Our Ref: OSK3426-0020  
Your Ref: A006067610

**RE: INFORMATION REQUEST FOR – 26 CLOVERDALE RD, DOOLANDELLA QLD 4077**

We refer to the Brisbane City Council's Information Request (IR) issued on 6 September 2022 regarding the Development Application lodged by QLD International Investment Pty Ltd C/- Nexus Urban Consulting Pty Ltd. On behalf of our client, please find below our response to the civil engineering items:

OSKA Consulting Group,  
Conceptual Stormwater Management Plan  
(Ref: OSK3426/P005/B);  
OSKA Consulting Group,  
Conceptual Stormwater Management Details  
(Ref: OSK3426/P006/B)

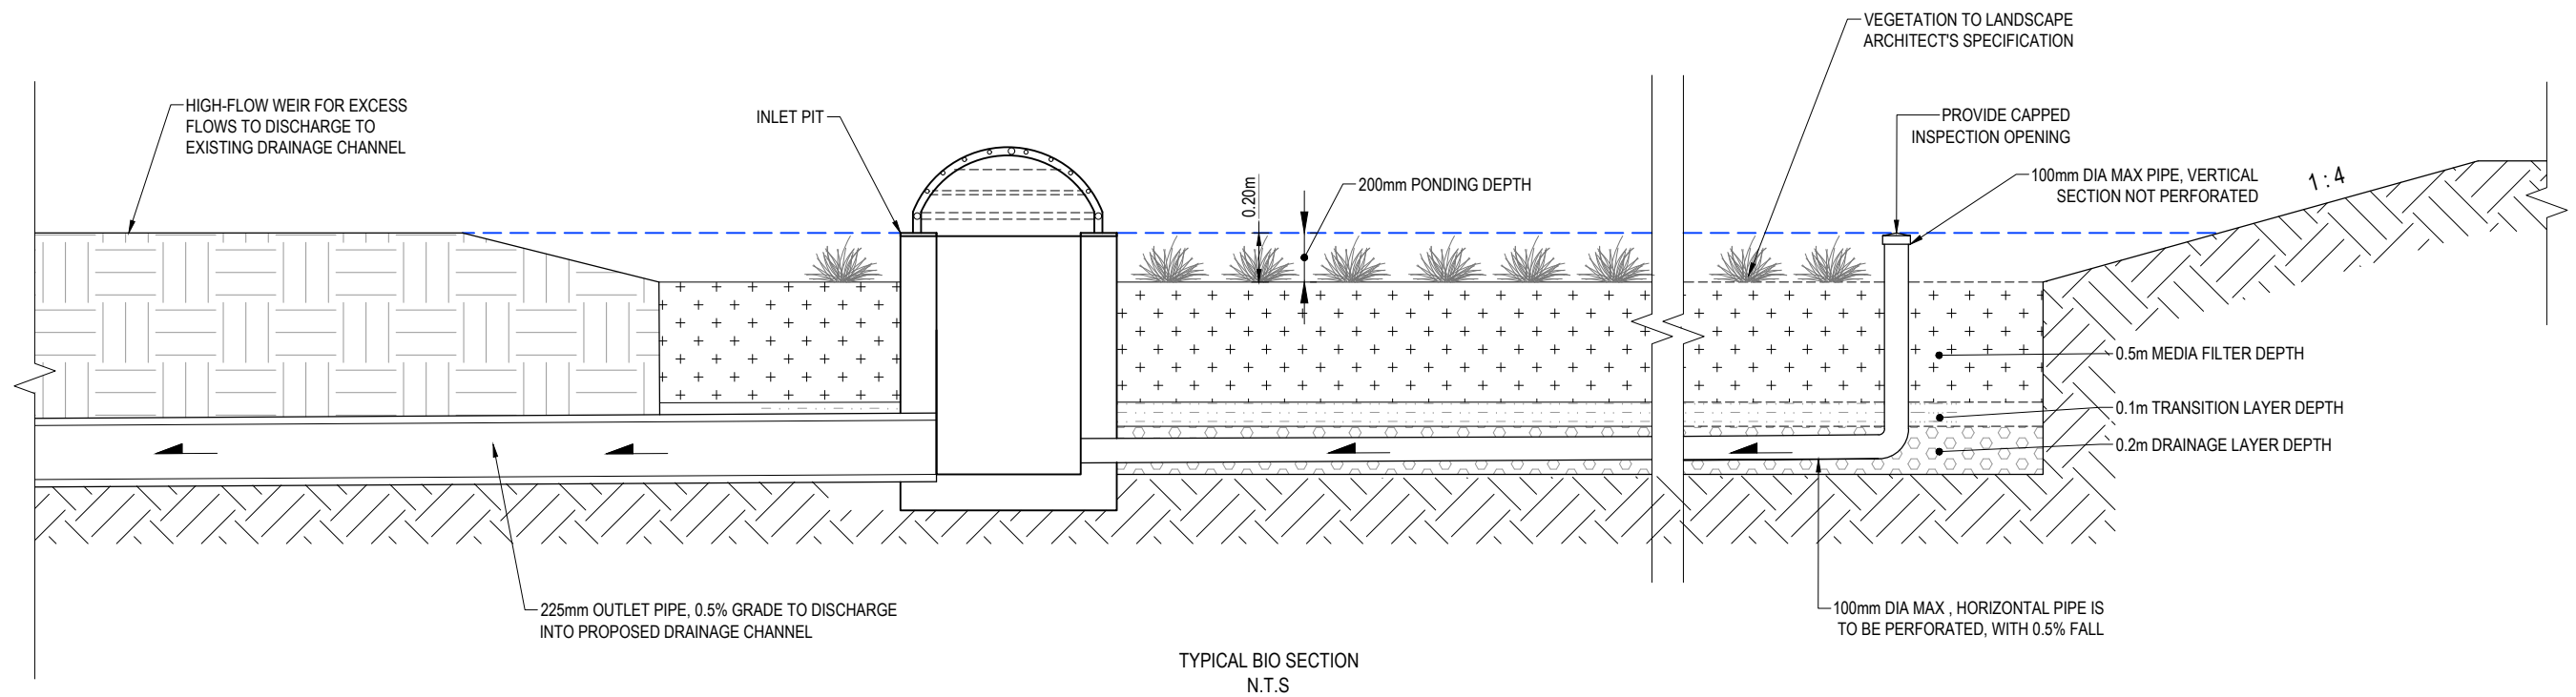
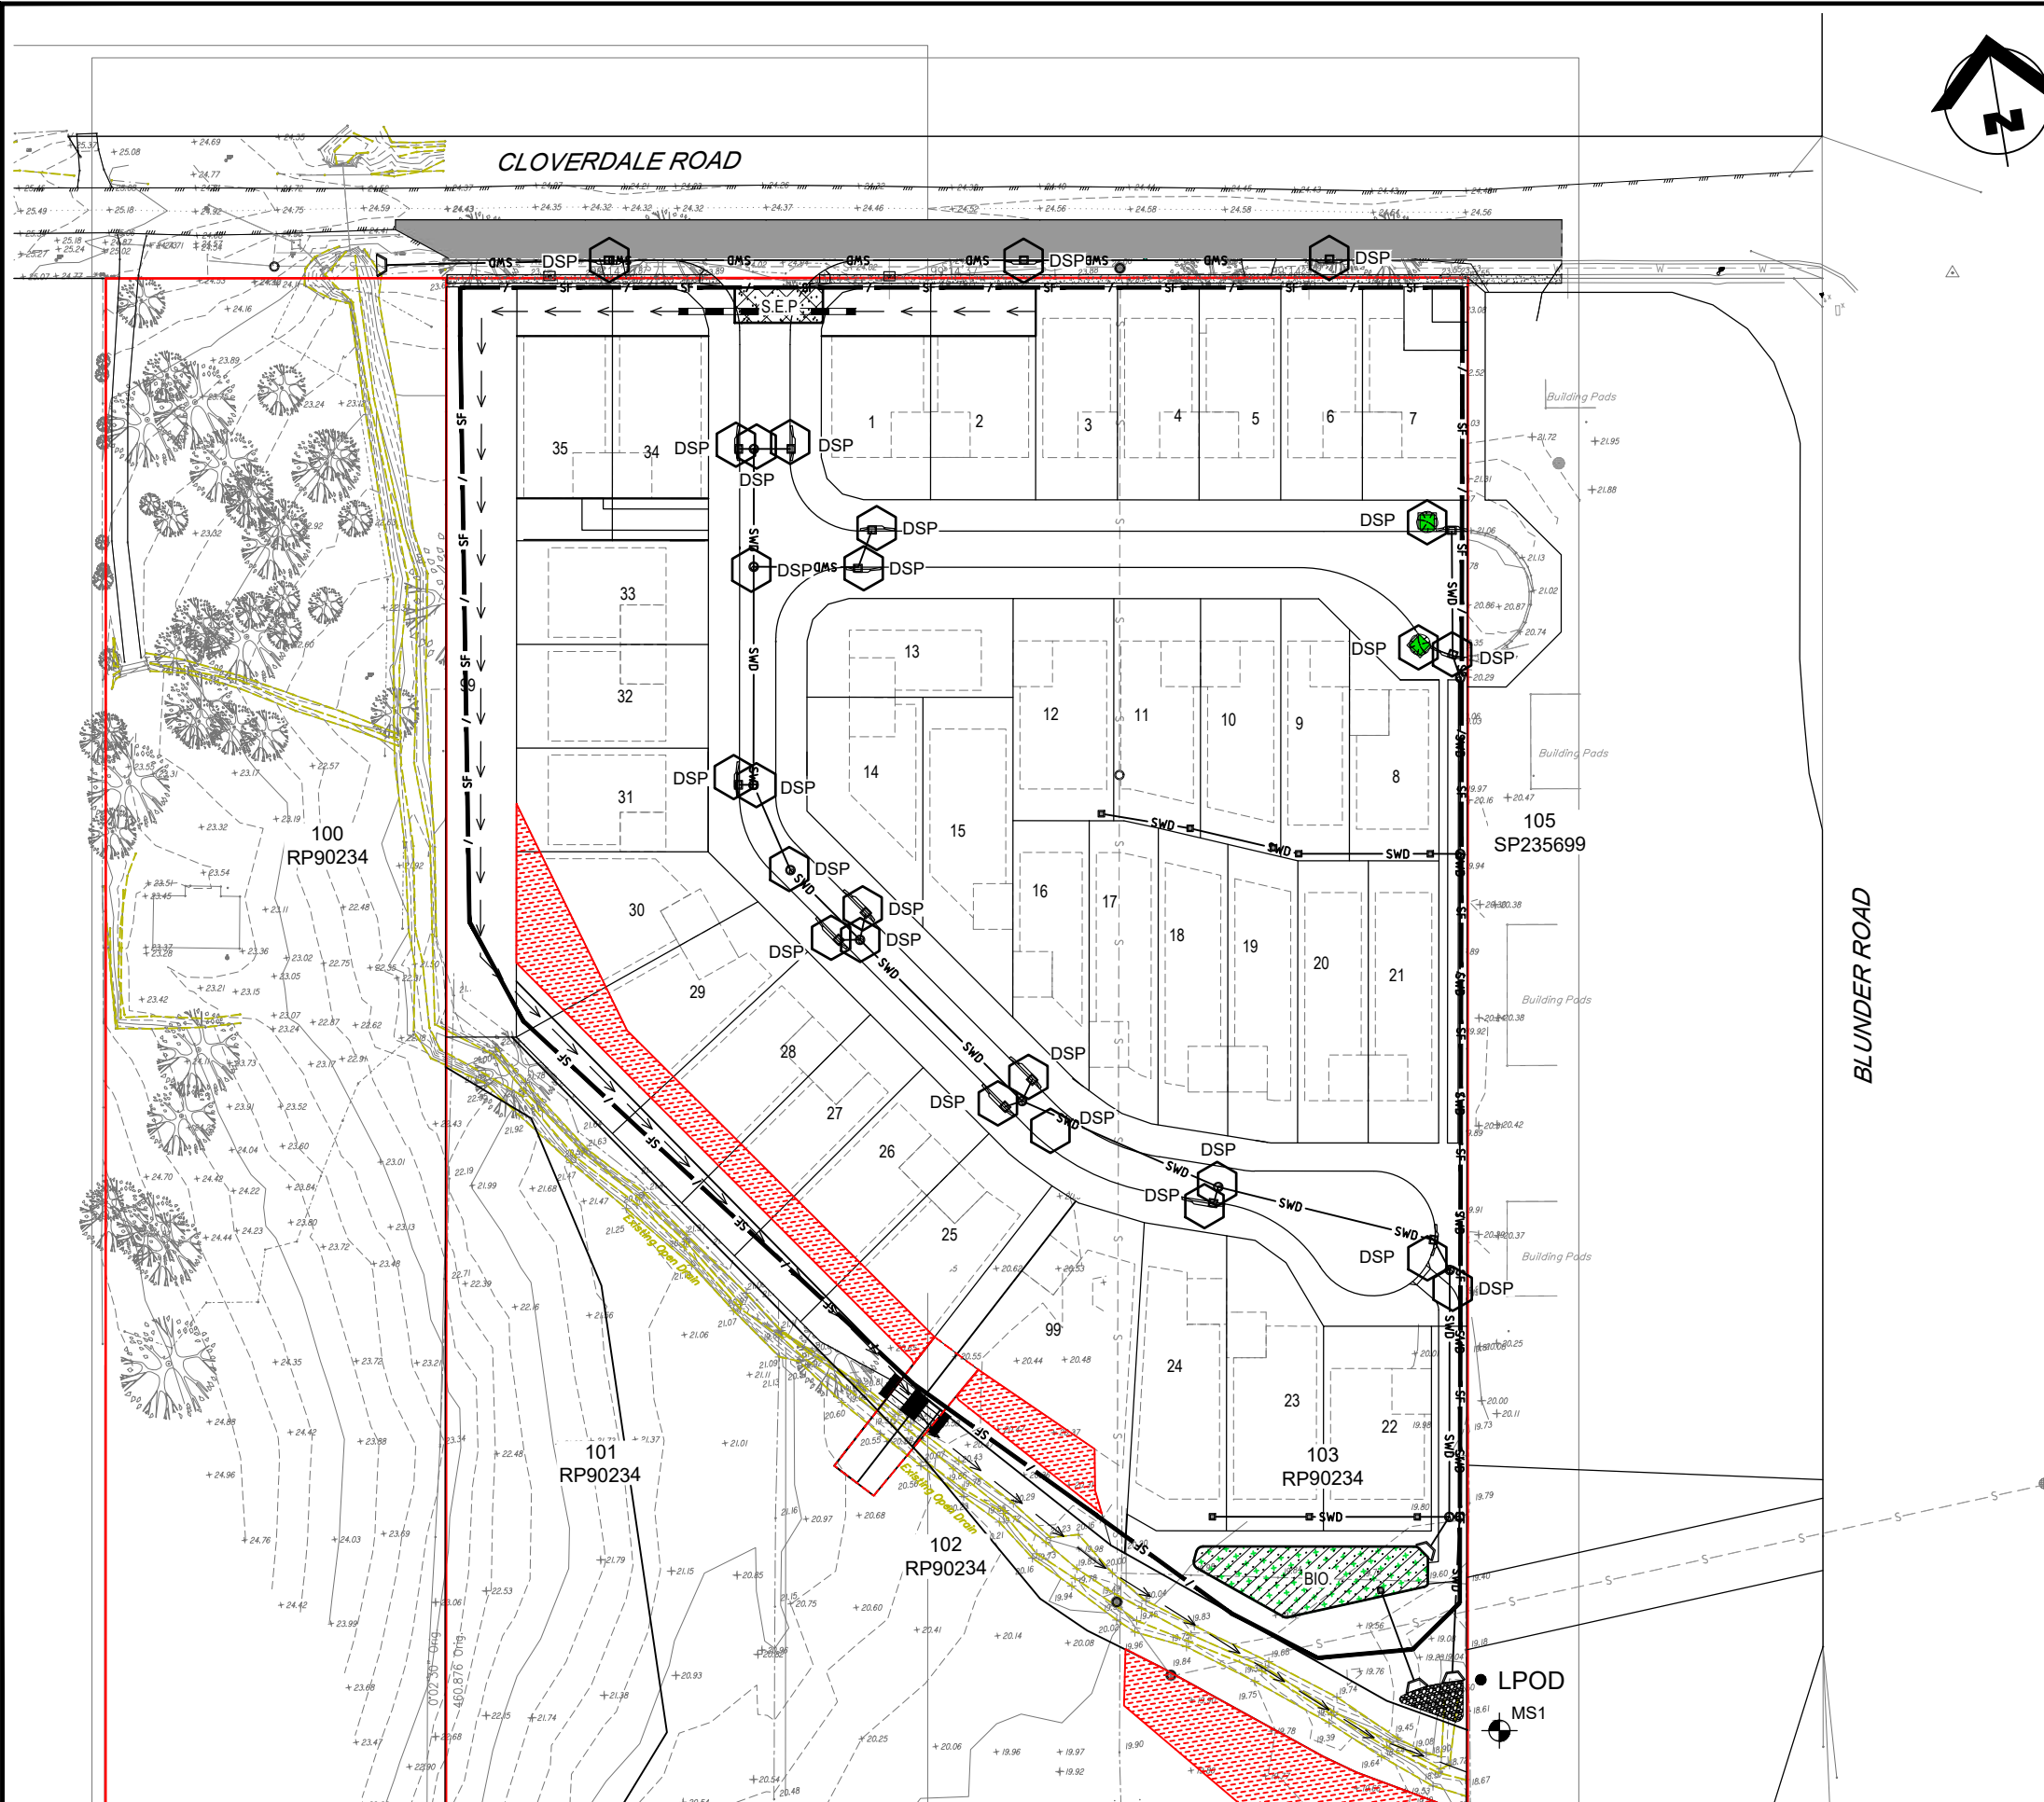
a) *Show the proposed bioretention basin with a minimum filter depth of 500mm, in lieu of the 400mm currently shown.*

*b) Show the proposed streetscape bioretention in the cul-de-sac with a maximum ponding depth of 100mm. The current 300mm ponding depth shown is not supported. Additionally, the surface area of filter for each device would only be 1.5sqm, as per BSD9034. Remove these treatments and pipe stormwater to the proposed bioretention basin.*

**RESPONSE:** The minimum filter media depth within the proposed bio-retention basin has been increased from 400mm to 500mm.

**RESPONSE:** The two proposed streetscape bio-retention pods within the existing cul-de-sac have been modified so each pod only has 1.5m<sup>2</sup> of filter area. Due to the design restrictions for the development with a requirement to tie into the existing cul-de-sac, stormwater was not able to be piped from the north-eastern corner of the site into the proposed bio-retention basin. As a result, the stormwater is discharged into the proposed stormwater network within the existing cul-de-sac with two bio-retention streetscape pods proposed to treat stormwater runoff from that catchment. The influencing catchment will not be included within the water quality modelling with Best Management Practices to be implemented for the bypassing catchment with the flows to be treated by two bio-retention street pits.
